**DRAINAGE EASEMENT ANALYSIS  
FOR  
7950 MALLARD DRIVE**

August 2018

DRAINAGE EASEMENT ANALYSIS  
7950 MALLARD DRIVE

# StreamStats Report-7950 Mallard Drive

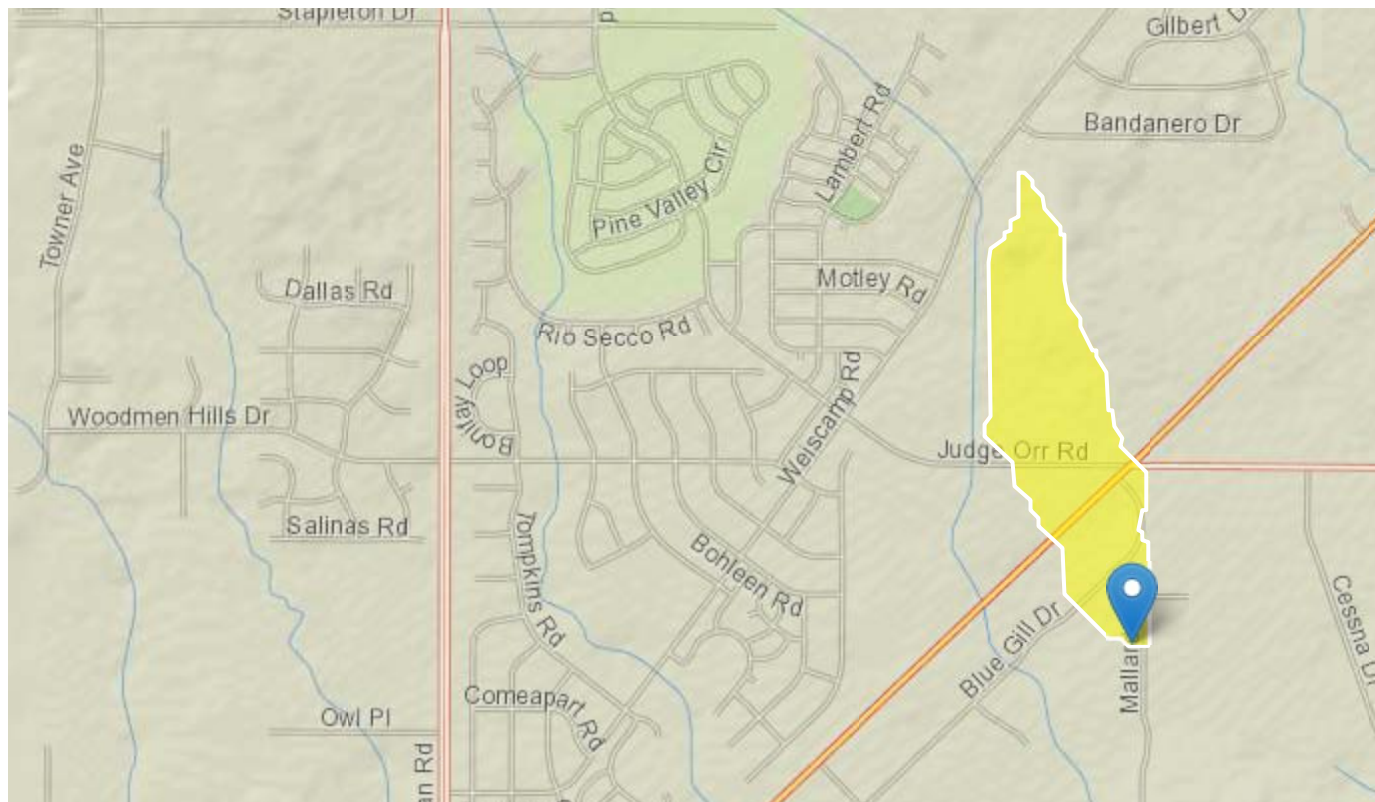
Provide, verify CN value

7950 MALLARD DRIVE
EASEMENT WIDTH ANALYSIS

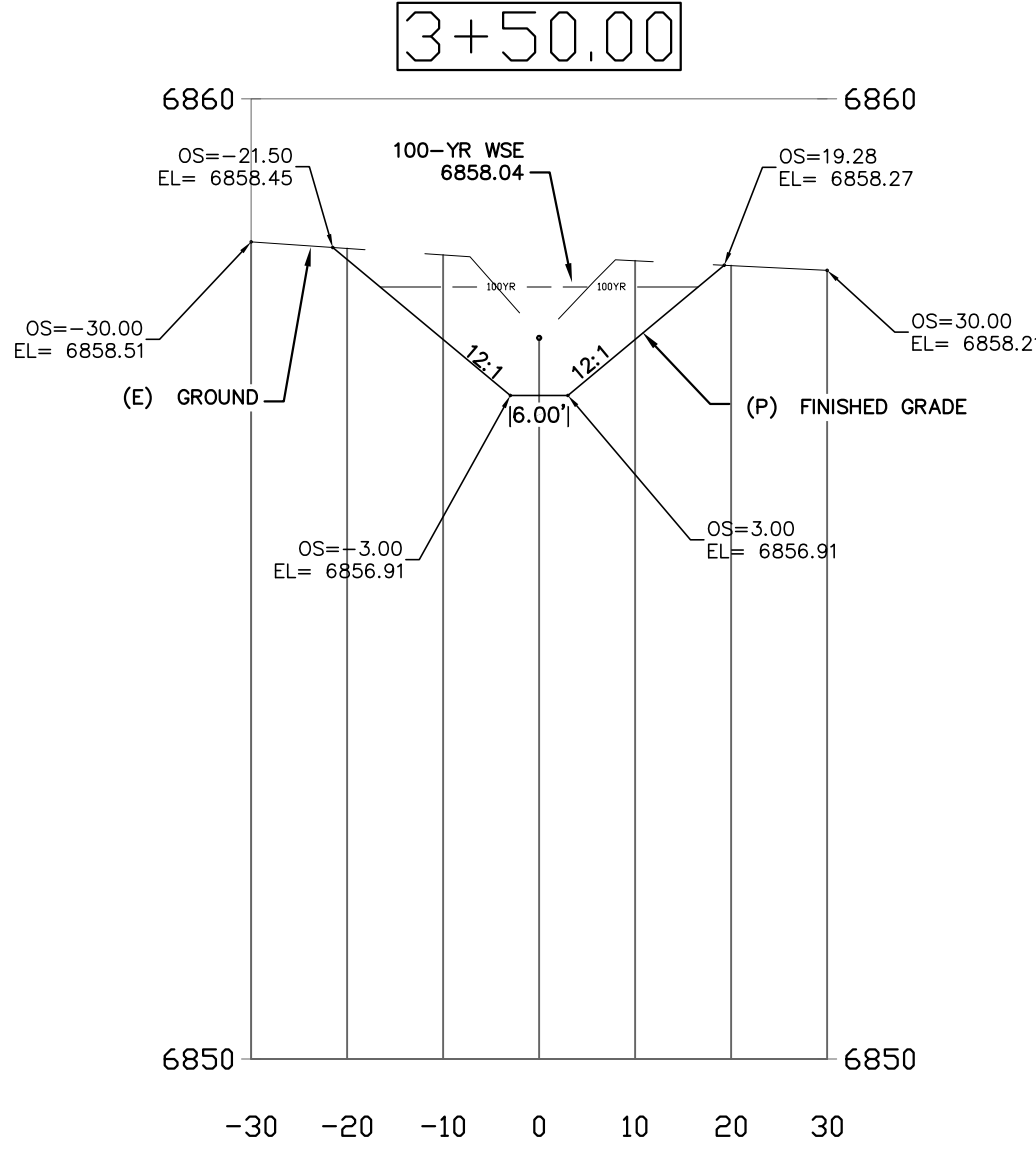
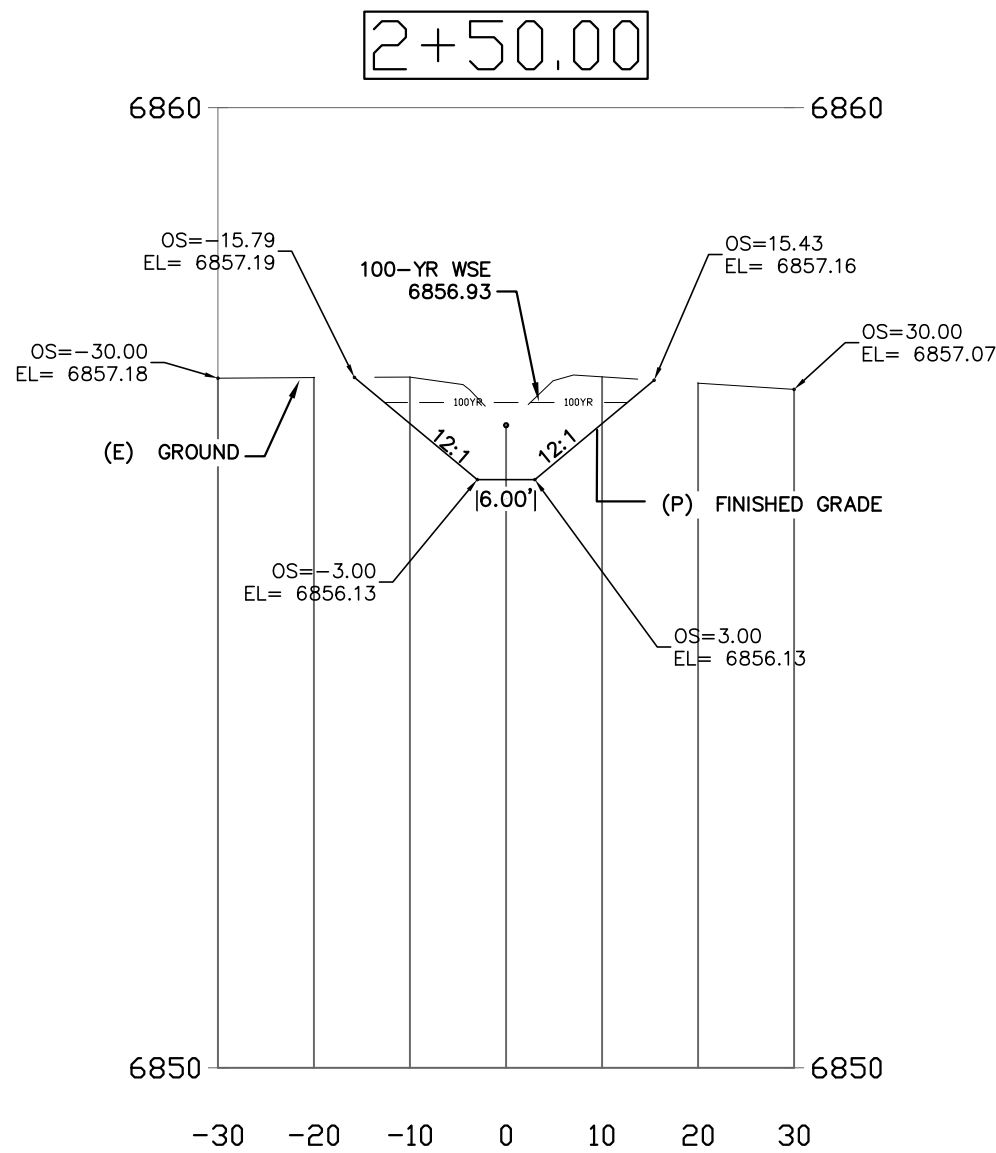
If the channel does not have capacity, where will the 100-year flood and developed emergency condition flood from the north go?

If developed channel ends here, where will overtopping go?
